Integrated Plant Safety Assessment Systematic Evaluation Program

Millstone Nuclear Power Station, Unit 1

Docket No. 50-245

Draft Report

Figure VI-7.C.1.-1a. 480 Volt Distribution 12E-12F Bus Before

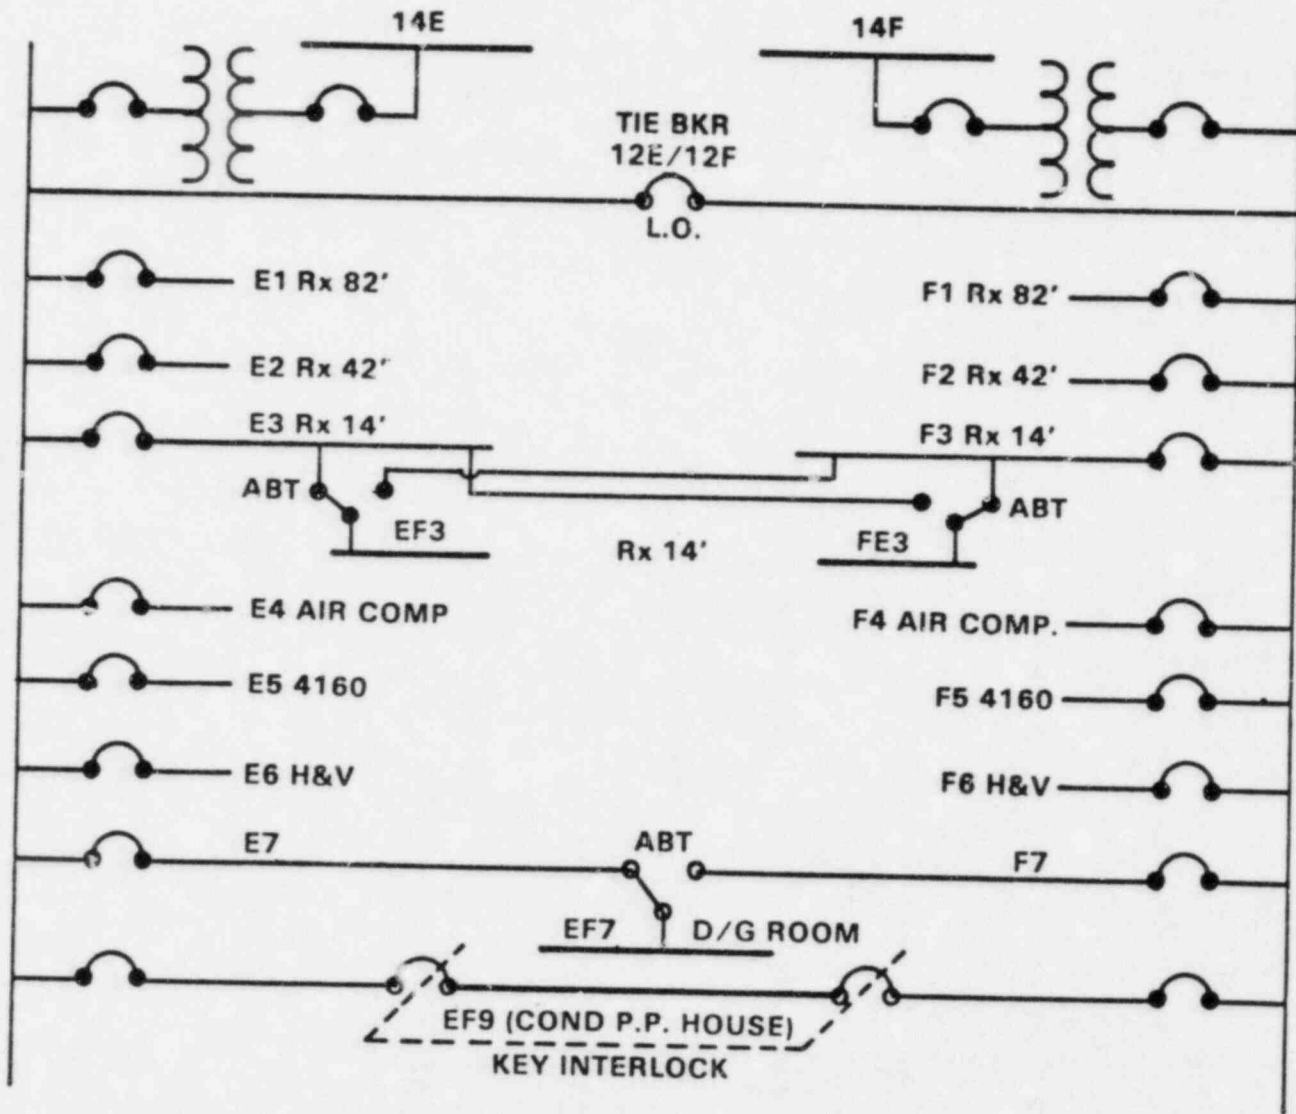
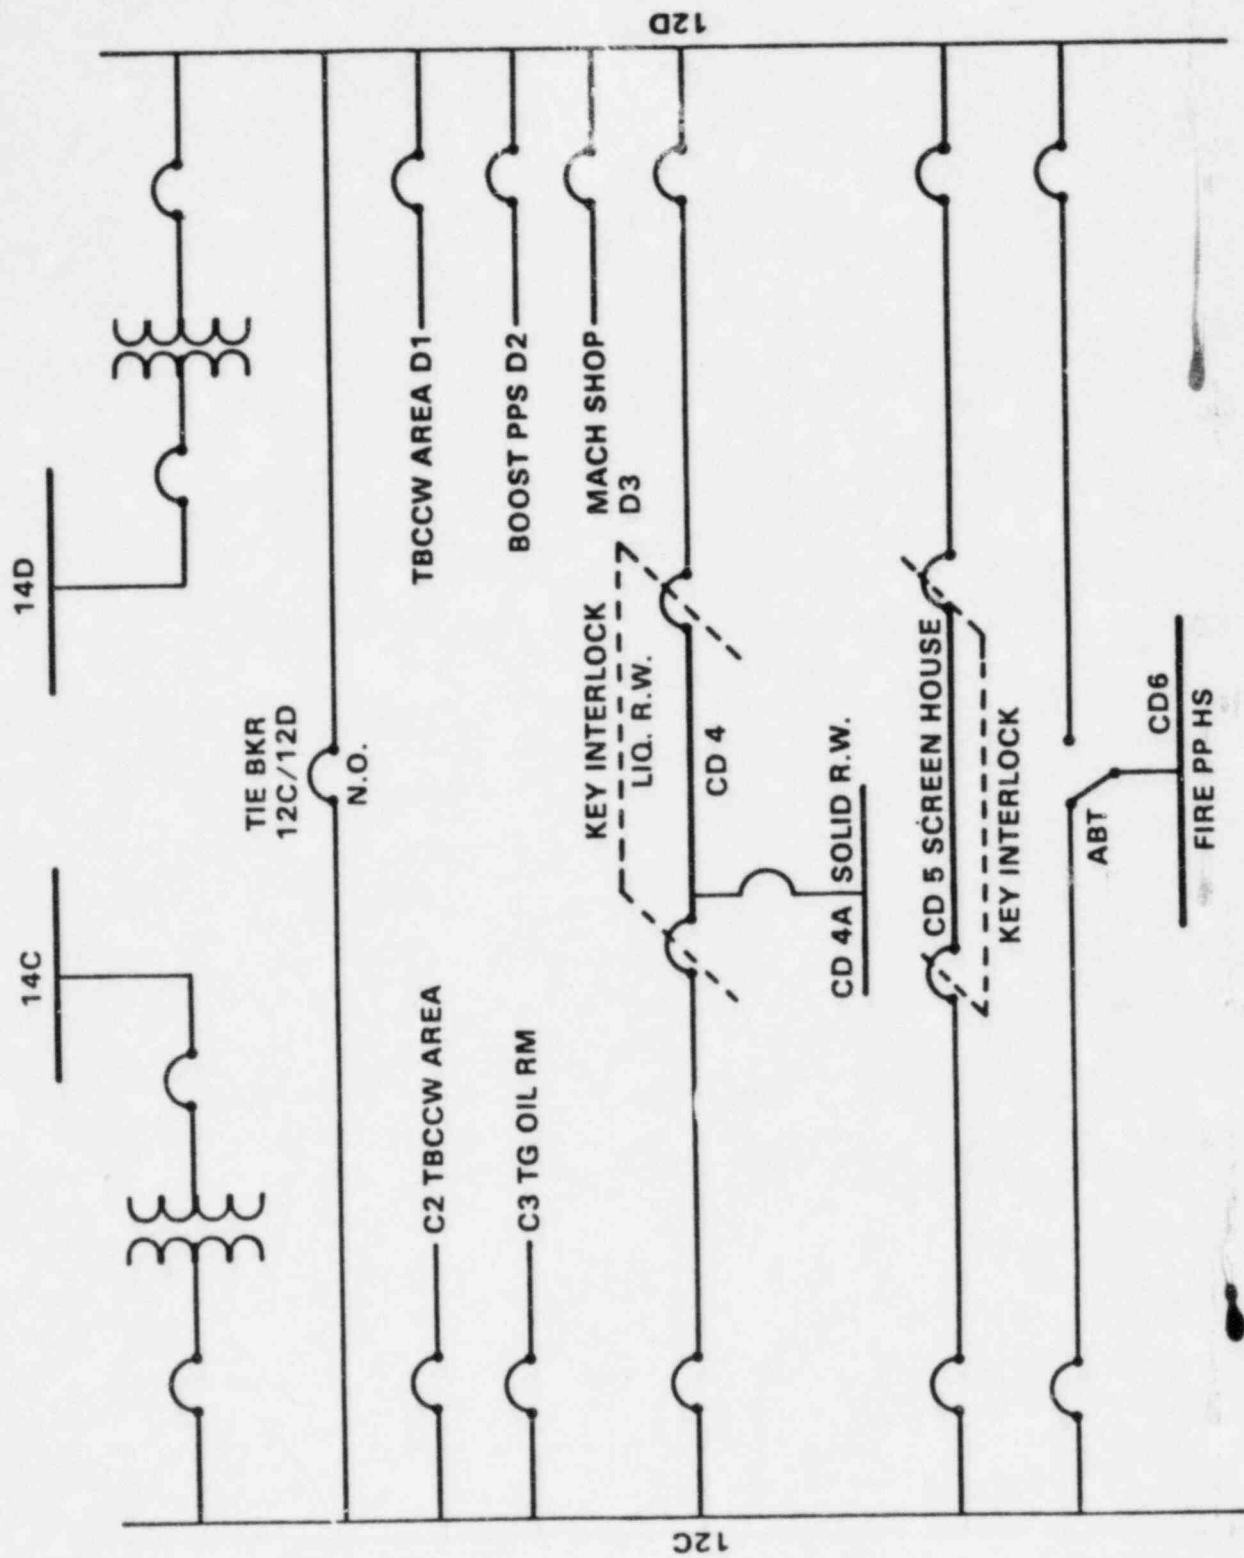
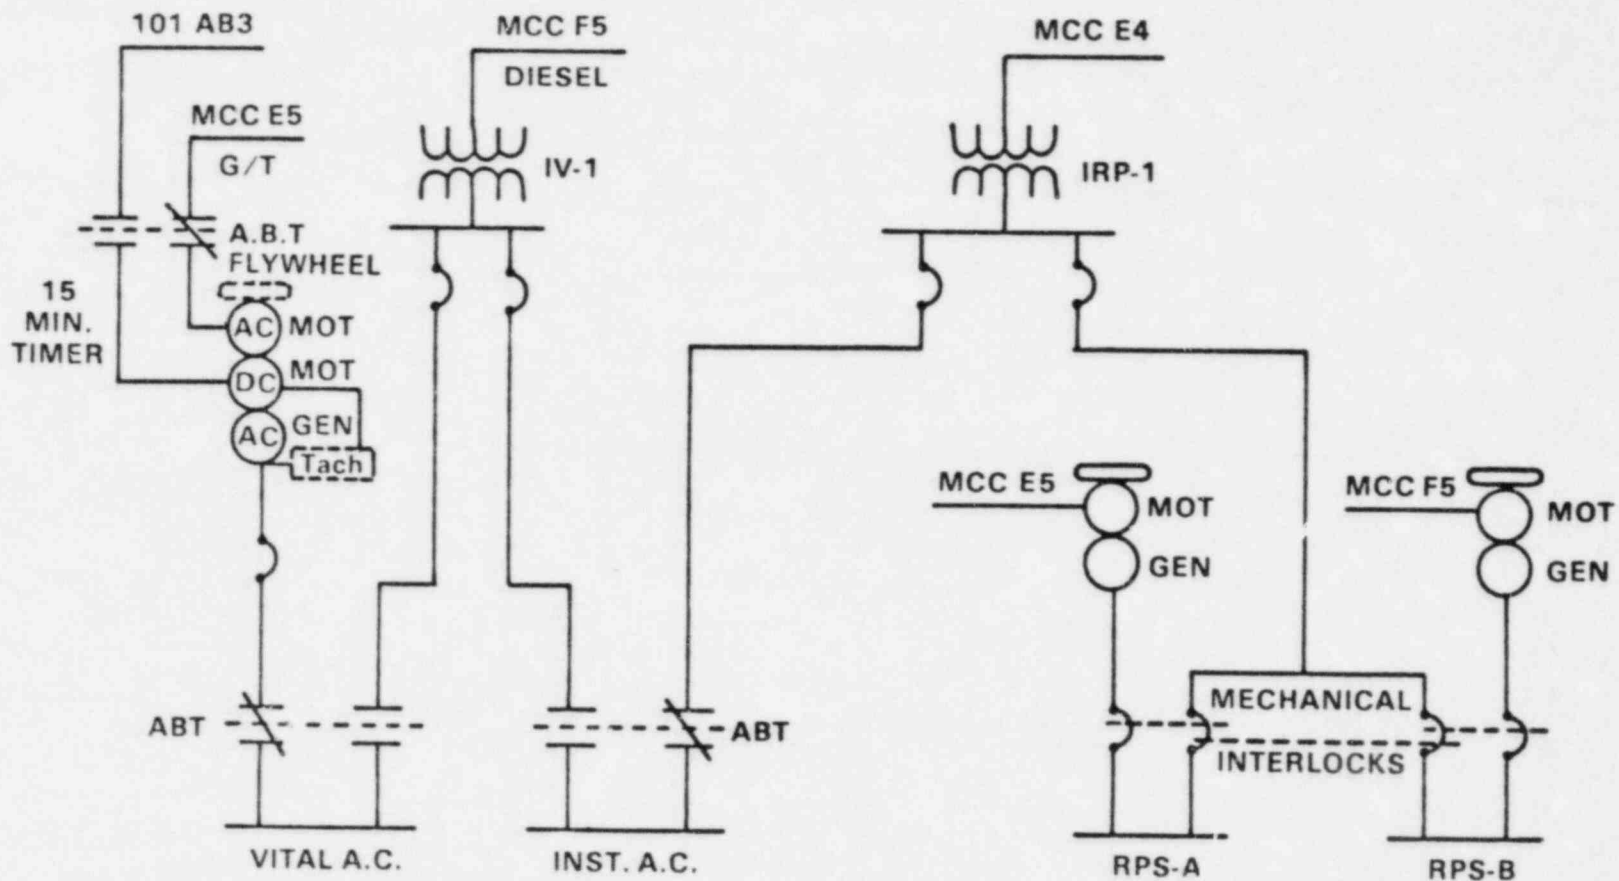
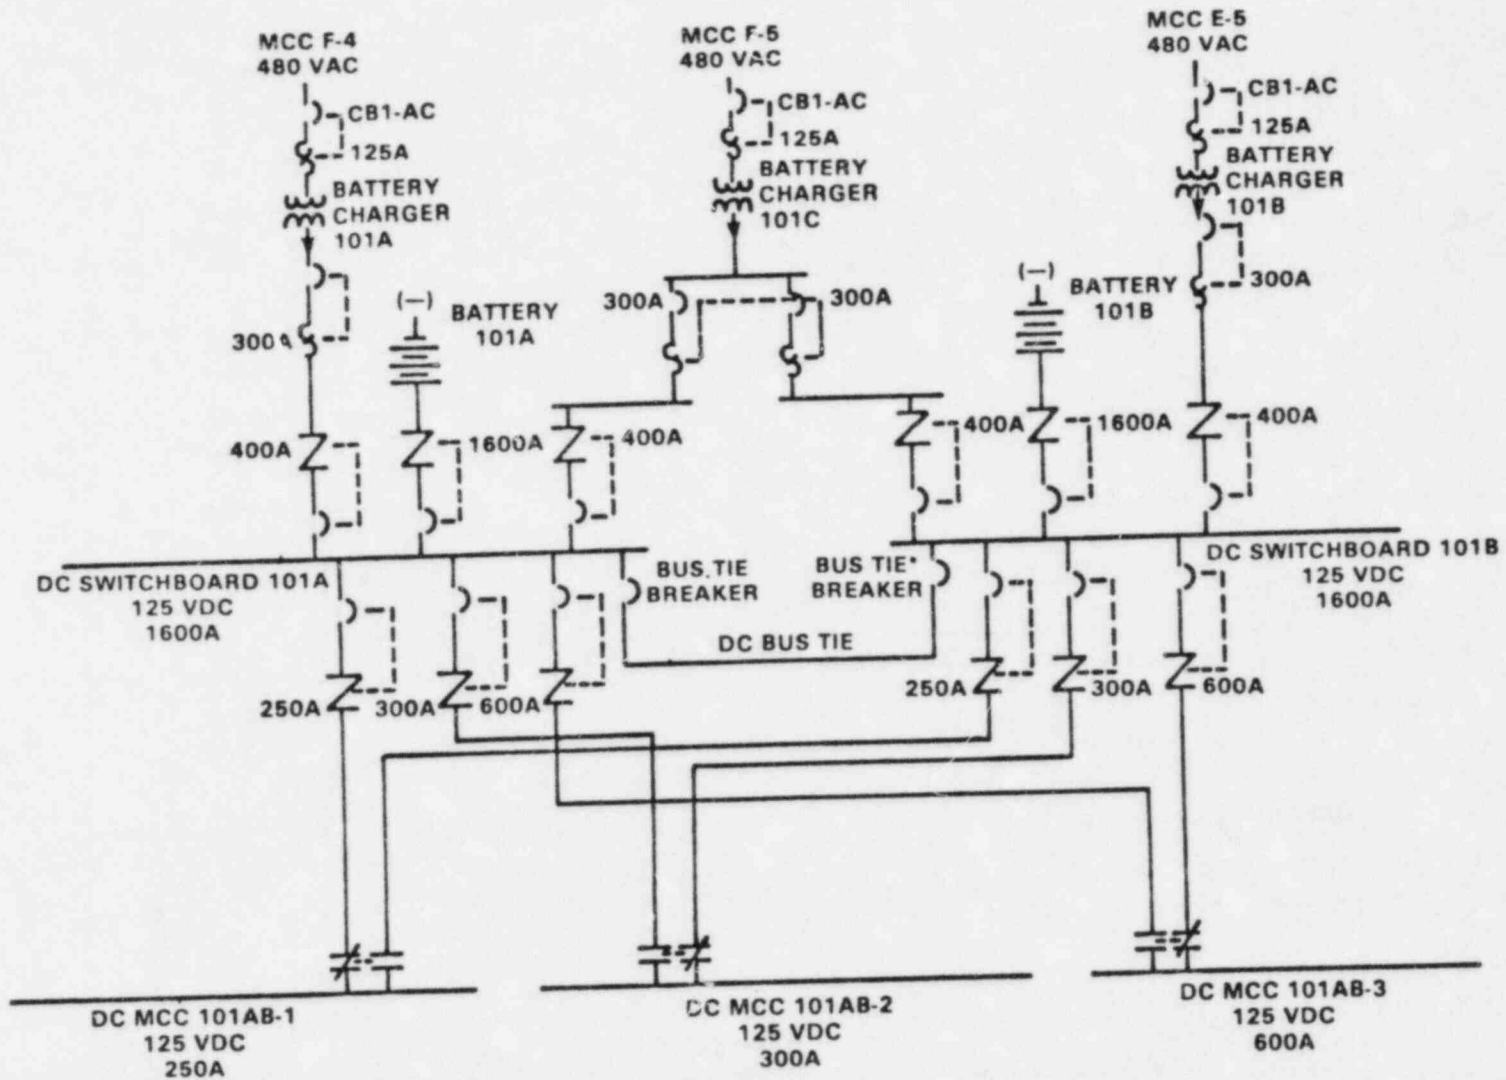
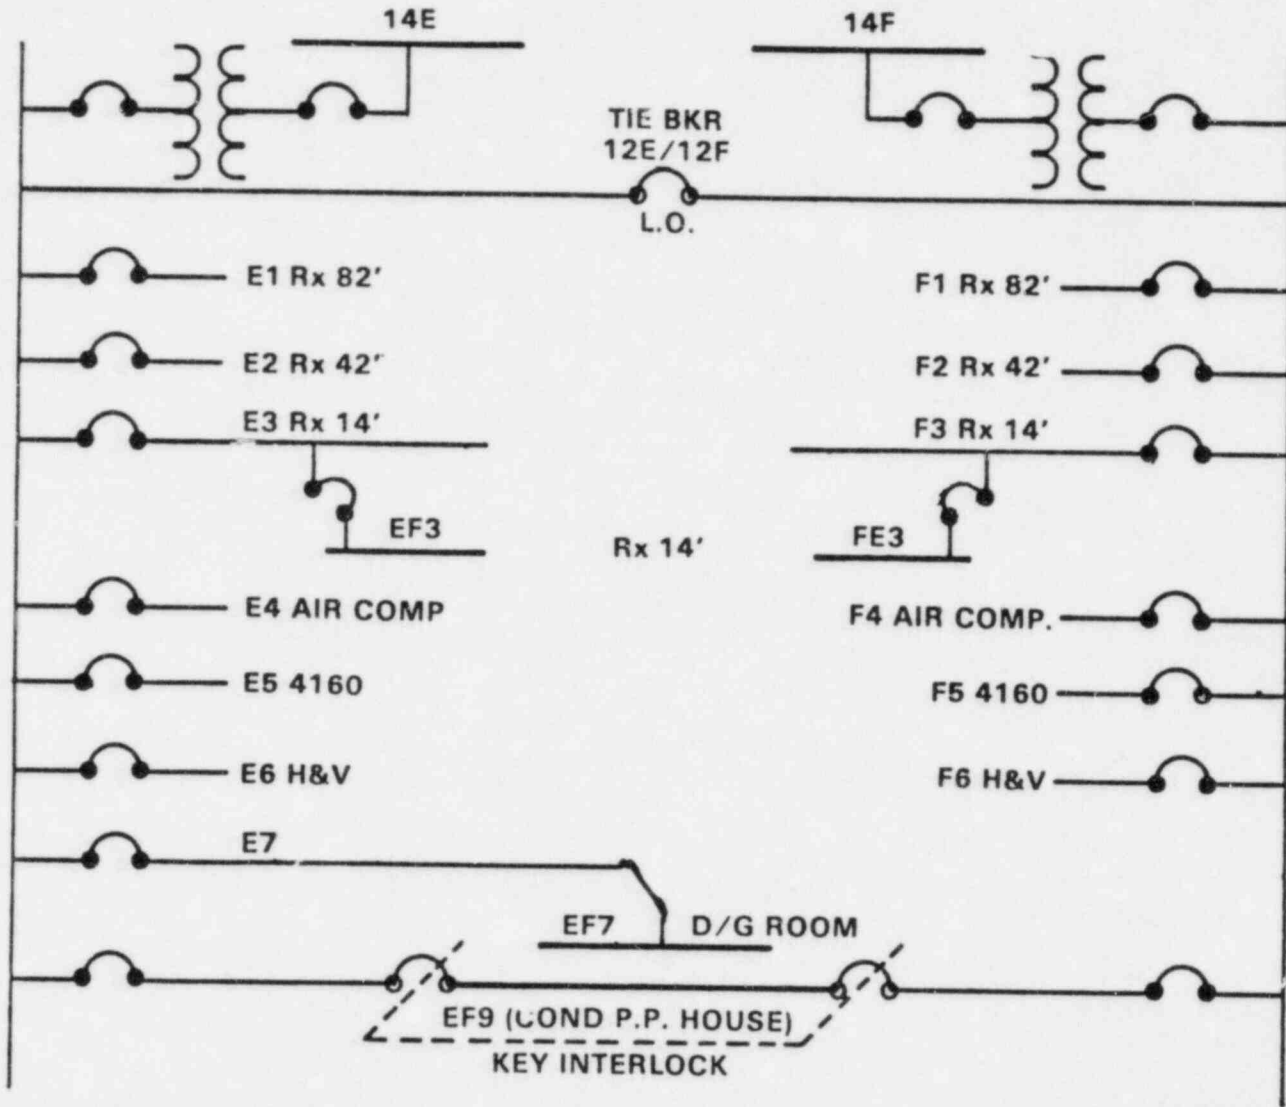
The present design of the ac and dc systems is shown in Figures VI-7.C.1-1a through VI-7.C.1-1d. They show automatic bus transfer devices on ac motor control centers EF3, FE3, EF7 and CD6 and on the Instrument ac (IAC) and Vital ac (VAC) buses, as well as manual transfers on dc motor control centers 101AB-1, 101AB-2, and 101AB-3. The ABT on the Vital ac bus does not actually transfer loads between redundant power sources since the M/G set acts as an isolation device. However, it was felt necessary to include this in the redesign for other reasons related to the need to redesign the Instrument ac (see issue VII-3). The changes for ac MCCs EF3, FE3, EF7 and CD6 simply involved removing the ABTs and hard wiring the buses directly to a power source. This is shown on Figures VI-7.C.1-2a and VI-7.C.1-2b. Similarly, for the dc MCCs AB-1, AB-2,

and AB-3, the manual bus transfers were removed as shown in Figure VI-7.C.1-2d. The redesign for the IAC and VAC buses were more complicated. This is because these buses do not supply redundant load groups. That is, they each supply needed service to the whole plant (this aspect is treated in issue VII-3). Thus, in order to remove the ABTs and therefore connect the bus to a particular power source, it becomes necessary to split the loads on these buses in half according to the associated equipment train which they affect. This resulted in a redesign which created separate IAC and VAC buses for each train. This is shown on Figure VI-7.C.1-2c. A further complication was that in the case of the control logic for the shutdown cooling system, only one logic train existed, as shown in Figure VI-7.C.1-3. This required the creation of a new control logic design which had two trains, one to be associated with each new IAC bus. This is shown on Figure VI-7.C.1-4 sheets 1 + 2. All these modifications were evaluated by changing the fault trees from the Millstone-1 Interim Reliability Evaluation Program (IREP) Study to represent the modified electrical power systems design discussed above, and then requantifying the dominant event tree sequences to determine if any risk reduction was realized.
